SOUTHERN REGIONAL PLANNING PANEL

JRPP No	2019STH001 DA
DA Number	DA-2018/1638
Local Government Area	Wollongong City
Proposed Development	Mixed use development – fourteen (14) storey building comprising of one hundred and two (102) residential units and eight (8) commercial tenancies over two (2) levels of basement parking
Street Address	71-77 Kembla Street, WOLLONGONG Lot 502 DP 845275
Applicant/Owner	Applicant – ADM Architects; Owner – City Investments Pty Ltd
Number of Submissions	Initial notification period - six (6) submissions in objection to the proposal Second notification period – 45 submissions in objection to the proposal
Regional Development Criteria	Clause 3, Schedule 4A of the Environmental Planning & Assessment Act 1979; general development over \$30 million. The applicant's CIV estimate for the project is \$43,270,000.
List of All Relevant s4.15(1)(a) Matters	<ul style="list-style-type: none"> ▪ List all of the relevant environmental planning instruments: s4.15(1)(a)(i) – <p><u>State Environmental Planning Policies (SEPPs):</u></p> <ul style="list-style-type: none"> ▪ SEPP No. 65 – Design Quality of Residential Apartment Development ▪ SEPP (Coastal Management) 2018

Figure 2 – extract of western elevation comparing original plans (upper) to revised plans (lower)

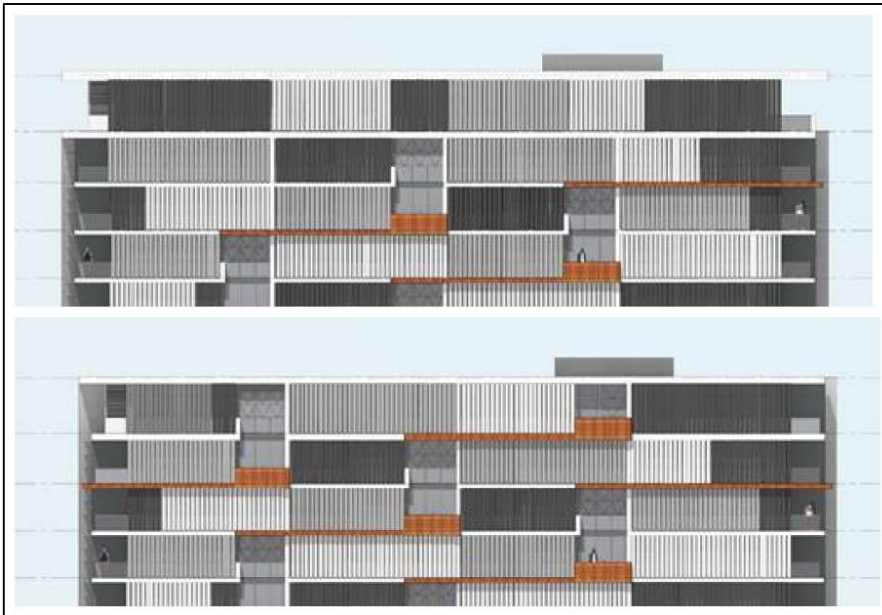
“The Panel was concerned that the penthouse was not well integrated into the built form and in such a prominent “public” locality, required further thought. Two design strategies were suggested for further study in order to provide a more resolved and amenable built form. In response to this comment, the top floor has been redesigned to maximize its site coverage, without stepping the building at its northern end to create a large open terrace (as suggested by the Panel). Hence, much greater physical and visual bulk is now proposed, exacerbating the non-compliance with the ADG’s setback requirements and its compatibility with the approved built form on its adjoining site (which as stated above, is not shown at all). Clearly, the Panel was seeking a more amenable built form to better integrate with its context: limiting its bulk, introducing landscape at its upper level, cutting back its roof where not required, introducing stepping and so on. The proposal instead increases its bulk and fails to demonstrate compatibility with adjoining properties and streetscape. It is therefore not acceptable. The redesigned penthouse also illustrates that additional bulk is not even necessary; the top level is dominated by large service and internal rooms, virtually every room is over sized and all perimeter balconies have been increased in depth. All the outdoor space – including the very deep north facing al fresco space – is proposed as covered space. This gives the penthouse a deep and internal character, dominated by a long corridor and deeply recessed living spaces. It is therefore not supported.

The rationalization of internal and external areas at the southern portion of the plan should allow for a large north facing landscaped terrace – of approximately 10m depth - as previously suggested by the Panel. The unit’s new north facing glazing should have a cantilevered roof eaves of no more than 2.5m to allow adequate solar penetration to living spaces. The northern edge of the terrace must have a 2m constructed landscaped planter to prevent overlooking to its adjoining boundary. The landscape treatment of the new private terrace must be thoughtfully

considered and designed to integrate tree planting to ameliorate the issues of bulk and separation identified above. The terrace at level 13 (described above) should extend south as far as the first structural bay (approximately ten metres from the northern façade on lower levels). The level 13 roof eaves should project no further north than the north side of the slot below.”

The applicant contends that the proponent agreed with the option of incorporating the penthouse within the general form of the building, as suggested by the Panel. ADM Architects subsequently amended the elevation to continue and integrate the penthouse level of the building with the same architectural language as the lower levels. This is demonstrated within the following extracts of the elevations which show the western and southern façade before and after the amendments: -

Council officers have considered the above response along with the earlier Panel commentary and consider that the applicant has adequately addressed the DRP’s earlier recommendation. The DRP provided 2 options for re-designing the penthouse to overcome the concern raised, and as iterated by the applicant, one of these options was taken up by the applicant – being to integrate the penthouse

level of the building with the remainder of the building below by continuing the same architectural language through that floor as is evident on the lower levels. This is clearly depicted in the plan extracts above. The applicant is correct in saying that the DRP suggested that consideration be given to “perhaps” setting back the penthouse level “from the northern edge to create a large north facing terrace” while in the most recent review, the Chair insists that the Level 13 floor plate “must be reduced” in size. The applicant’s justification for not further amending the plans is considered to be adequate and the development in its current form is supported from a planning perspective. The scale of the penthouse unit does not give rise to any LEP or ADG departures at that level nor any off-site impacts as outlined in this report.

Figure 5 – building separation development departure to northern boundary

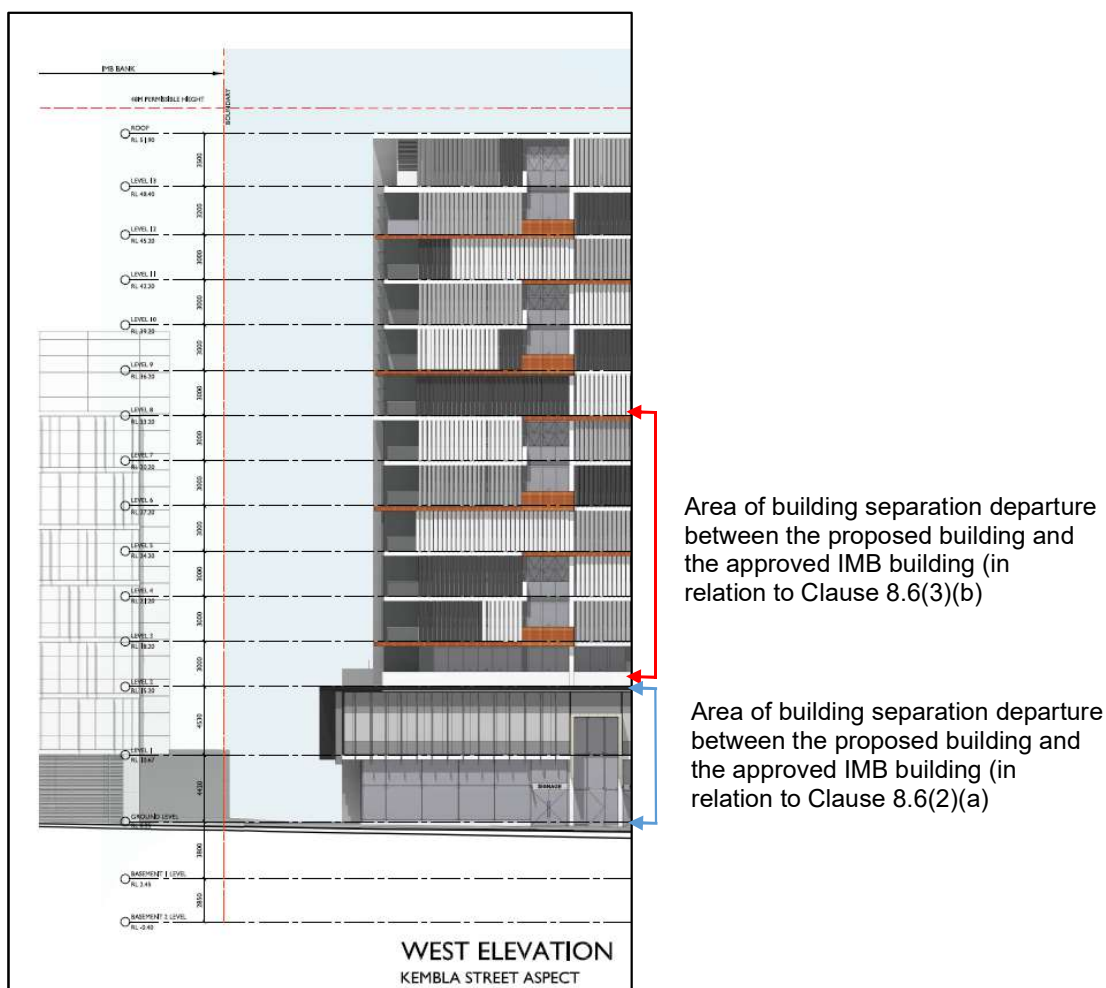
Further, variation to the 16m separation to the IMB building, as specified by clause 8.6(3)(b) is also sought. Levels 2 – 13 of the development contain residential units and are setback between 14.260m from the southern wall of the approved IMB building/ 10.6m from the northern boundary. The departure in respect of Clause 8.6 (3)(b) pertains to that part of the building up to the equivalent height of the IMB building (ie levels 2 – 7 of Building A):-

<p>(b) that there are sufficient environmental planning grounds to justify contravening the development standard.</p>	<p>Yes, the applicant's request contains this justification.</p>
<p>4.6 (4) (a) Consent authority is satisfied that:</p>	
<p>(i) the applicant's written request has adequately addressed the matters required to be demonstrated by subclause (3), and</p>	<p>The applicant's request has adequately addressed the matters required to be addressed by subclause (3).</p> <p>The applicant's request is based on the rationale that the variation to Clause 8.6 is considered to be consistent with the objectives of the clause and, that in the specific circumstances of the site, a better and more appropriate development outcome is achieved by allowing flexibility to the development standard.</p> <p>Generally speaking, the development better responds to the pattern of development in the immediate locality where continuous street walls are not evident.</p> <p>The objective of this clause is to ensure sufficient separation of buildings for reasons of visual appearance, privacy and solar access. It is considered that strict compliance with Clause 8.6 would hinder the achievement of this objective. If strict compliance was insisted upon within the site, this would result in reduced separation between buildings to the north and east at Ground Level and Level 1 which would preclude the ability to provide the proposed shared driveway arrangement between the 2 adjoining sites. A zero setback to the north would not reflect the existing streetscape pattern nor allow for appropriate placement of service areas. Further, a nil separation to the east would result in a 2 storey blank wall when viewed from the east, which would not meet the objective of the clause with regard to visual appearance.</p> <p>Separation between the IMB building and the residential units sited on Levels 2 – 7 is marginally below the required 16m (at 14.51m). Given the design proposed, it is considered that there is sufficient physical separation available between the buildings. The design adequately addresses solar access and privacy to the residential</p>

<p>units through the inclusion of blank walls in places and fixed louvres as indicated in the below plan extract.</p> 
<p>(ii) the proposed development will be in the public interest because it is consistent with the objectives of the particular standard and the objectives for development within the zone in which the development is proposed to be carried out, and</p>	<p>The proposed development will be in the public interest because (a) it is consistent with the objectives of the building separation standard; (b) the objectives for development within the B3 zone will be achieved; (c) the development is not expected to compromise the development potential of neighbouring sites and will provide for an improved relationship with neighbouring and nearby buildings.</p> <p>The objectives of the standard are to ensure sufficient separation of buildings for reasons of visual appearance, privacy and solar access. The development, despite the non-compliance with the building separation standard, will be consistent with the objectives of that standard.</p> <p>The variation of the standard provides for a building which better responds to its context. In relation to visual appearance, as noted above, the building setbacks to the boundaries reflect the prevailing built form character of development in the civic/ governance precinct where buildings are setback from Burelli, Kembla and Stewart Streets and from their side boundaries. There is no continuous street wall to either Burelli, Kembla or Stewart Streets and insistence on adherence with the separation controls in Clause 8.6 would result in a built form outcome at odds with nearby buildings including nearby heritage items.</p> <p>The departure will not have any adverse impacts on the amenity of nearby developments, the streetscape or public domain. There will be no additional overshadowing impacts arising from the development departure, no view impacts, no privacy impacts, no adverse impacts on the streetscape or any heritage items.</p> <p>Part of the non-compliance arises due to the position of the neighbouring buildings to the east and north of the site so strict compliance could not be achieved in any event. The provision of the shared driveway is an efficient use of space in the safest distance from nearest intersections.</p> <p>There is not considered to be a public benefit served in this instance by insisting on strict compliance with the standard.</p> <p>As outlined in section 2.1.5 the proposed development has regard to the objectives for development within the zone.</p> <p>The development will remain consistent with the objectives of the B3 zone despite the non-compliance with Clause 8.6.</p>

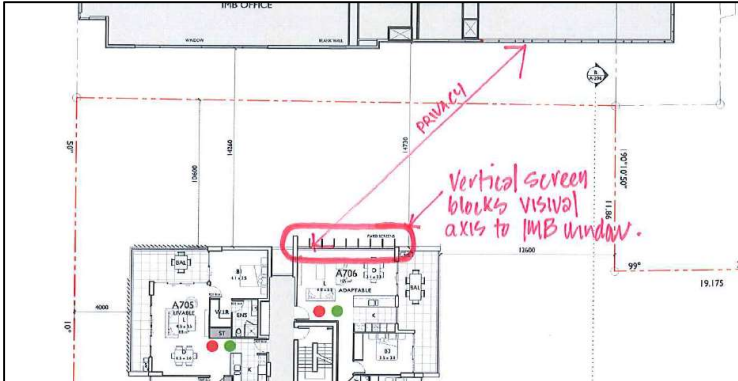
The development cannot provide for a compliant setback to the buildings to the east of the site (where no separation between neighbouring buildings up to the street frontage height is required by Clause 8.6) as the closest building (Sacred Heart Church) is sited some distance away. The space between the eastern boundary and the Church comprises the surface car park to the Church property and an access driveway servicing the building known as 'Corporate Square' fronting Burelli Street. The development is setback between 0m in the north-eastern corner of the site, increasing to 3.4m to the south-eastern corner of the ground floor.

The development can achieve compliance with the 16m separation distance required to the east for the residential units contained within Levels 2 – 7. In this direction there is a setback of approx. 25m available between the proposed eastern wall of the development and the Church.

Figure 7 – IRT Parkside building – provided by TCG Planning

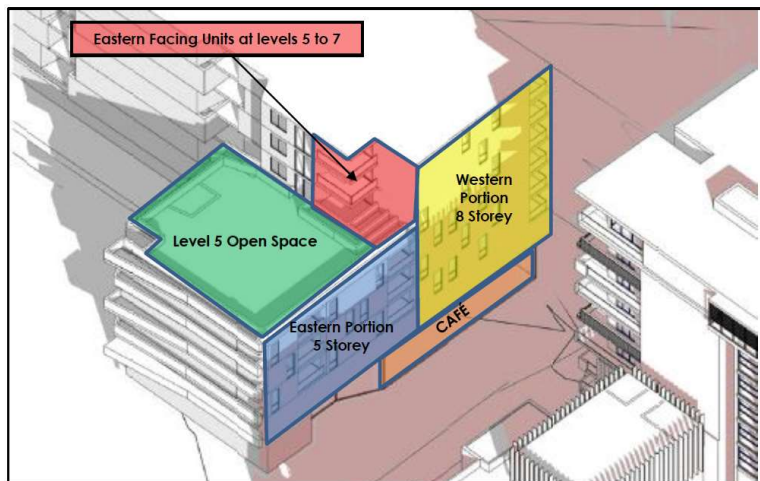
As illustrated above, the 'Parkside' building located to the immediate south of the site comprises two linked elements being an 8 storey west-facing block closest to the intersection of Stewart and Kembla Streets. This section is occupied by residential units on Levels 2-7 generally oriented to the east/west and south; and a ground floor café along the Stewart Street frontage. The second portion comprises a 5 storey north-facing block with frontage to Stewart Street – this is occupied by residential units at Levels 2-4 oriented to the north or south. There is also a communal open space located at Level 5 in this eastern section of the building.

- The western portion of the building contains three (3) eastern facing units on Levels 5-7s (highlighted pink on Figure 7), which have balconies and main living room windows oriented over the L5 communal open space. Bedroom windows are generally located on the northern façade of the building (except one narrow secondary living room window at Level 5). These east-facing units receive morning sunlight between 9am and approximately 10.30am. Whilst afternoon sun is impacted by the proposed development, it should be noted that the 'Pioneer Place' building itself overshadows such units in the afternoon period. These are the units most greatly affected by overshadowing are the three (3) east-facing units at Levels 5-7 of the

- Five (5) of the six (6) north-facing units within the lower, eastern portion of the building (highlighted blue in Figure 7) will not receive the required 3 hours of sunlight on June 21. Specifically, on L4 in this portion of the building, the majority of this level will be clear of shadow at 9am, with the living room and balcony of the eastern unit receiving sunlight through until approx. 11.30am. The balcony and primary living room window of the western unit will receive sunlight between 9am and 10.30am and will again receive sunlight between 1.30pm and 3pm. The living room and POS of the units at Level 4 in the eastern portion of the building will receive between approximately 2.5 to 3.0 hours of sunlight on June 21. On L3, the living room and POS of the eastern unit will receive sunlight between approximately 9.30am - 11.30am and between approximately 2.30pm - 3.00pm. The balcony and primary living room window of the western unit will receive sunlight between approximately 1.30pm - 3.00pm. Hence, the living room and POS of the units at Level 3 in the eastern portion of the building will receive between approximately 1.5 to 2.5 hours of sunlight on June 21. On L2, the living room and POS of the eastern unit will receive sunlight between approximately 2.30pm and 3.00pm. The balcony and primary living room window of the western unit will receive sunlight between approximately 1.30pm - 3.00pm. Hence, the living room and POS of the units at Level 2 in the eastern portion of the building will receive between approximately 0.5 to 1.5 hours of sunlight on June 21.

- Whilst the 3 eastern facing units at Levels 5-7 of the building do not provide the required 3 hours, it should be noted that the 'Pioneer Place' building itself overshadows the eastern facing units in the afternoon period."
